Model: Z-C1		Date: 16-Apr-15	No.: RM028049
Subject: Countermeasure for SC240/241		Prepared by: H. Someya	
From: 1st Tech Service Sect., MFP/P Tech Service Dept.			
Classification:	<input checked="" type="checkbox"/> Troubleshooting	<input type="checkbox"/> Part information	<input checked="" type="checkbox"/> Action required
	<input type="checkbox"/> Mechanical	<input type="checkbox"/> Electrical	<input type="checkbox"/> Service manual revision
	<input type="checkbox"/> Paper path	<input type="checkbox"/> Transmit/receive	<input type="checkbox"/> Retrofit information
	<input type="checkbox"/> Product Safety	<input type="checkbox"/> Other ()	<input type="checkbox"/> Tier 2

This is to inform about the countermeasure for SC240/241. If this symptom occurs, the LD unit which is very expensive, is damaged and is needed to be replaced. Replacing the LD unit can be a solution at the moment just to the machine back to ready to use, but cannot be a permanent countermeasure. The countermeasure is only installing the additional board described hereunder.

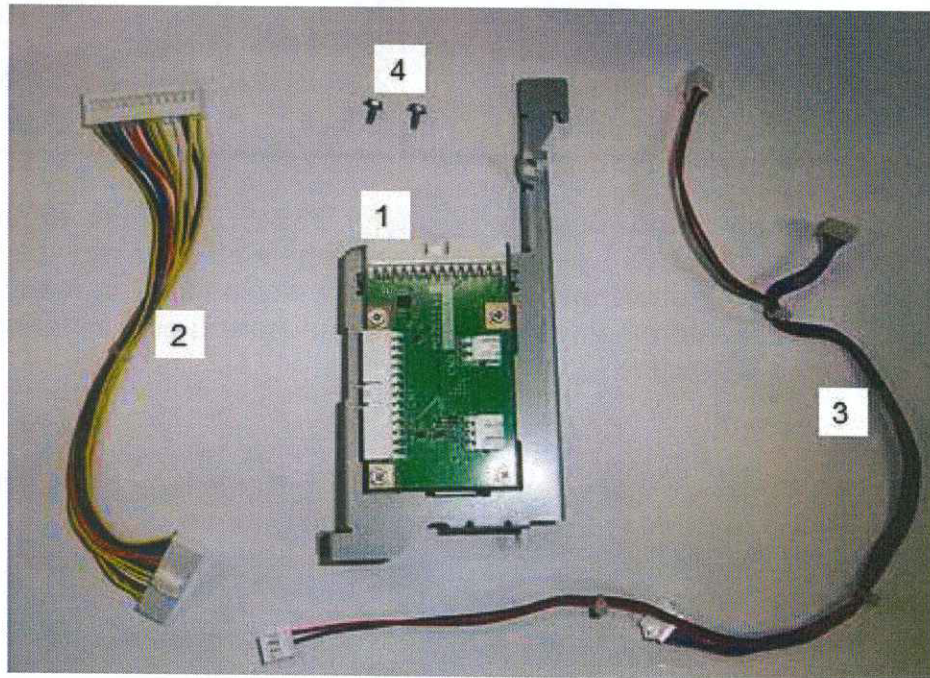
Instead, a small board like a smart phone is additionally installed for the purpose of field fix. This is easier to handle in the field and cheaper solution.

Install the board by obtaining either kit below. There are two part numbers for distribution purpose but both kits are exactly the same. Refer to next page for the component parts.

Part Number	Description	Note
D2345000	PCB:5VSCNT:ASS'Y	Available in parts center
M0269904	PCB:5VSCNT:ASS'Y	Not available in parts center
